Model : iR1230

Ref.No. : FF-T01-L6 -000056-UK1

Location : ADF ASSEMBLY (2/2)

Subject : The shape of member part changed

The attachment is a part of the Parts Catalog FIGURE161.

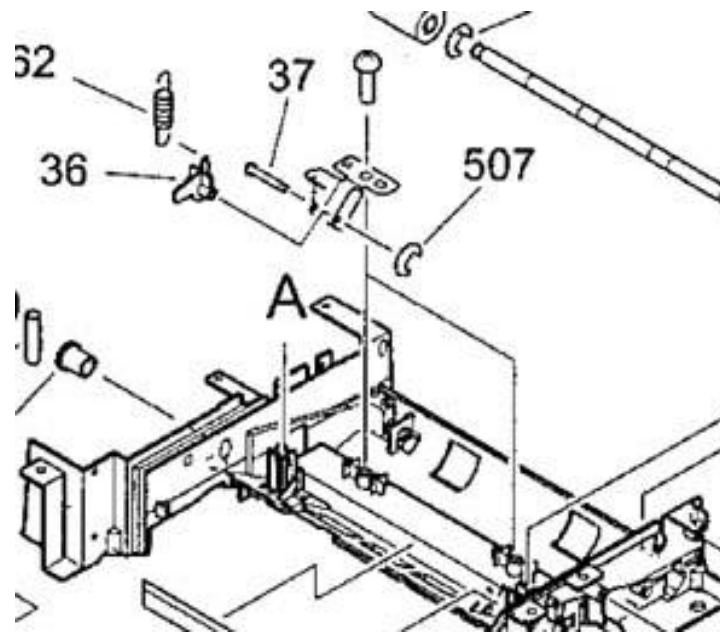
XD2-1100-242 (RING, E; See 507 in the attachment) prevented coming off of FC5-0054-000 (SHAFT, REGIST PRESSURE ARM; See 37 in the attachment).

However, the shape of the base part attached to FC5-0054-000 is changed this time to prevent FC5-0054-000's coming off instead.

Therefore, XD2-1100-242 is not used with this change.

In addition, the groove of FC5-0054-000 to attach XD2-1100-242 is not used.

FC5-0054-000 with groove is stored.

For the products manufactured before this change, XD2-1100-242 is stored.

In the case that FC5-0054-000 cannot be attached to the base part, remove XD2-1100-242.
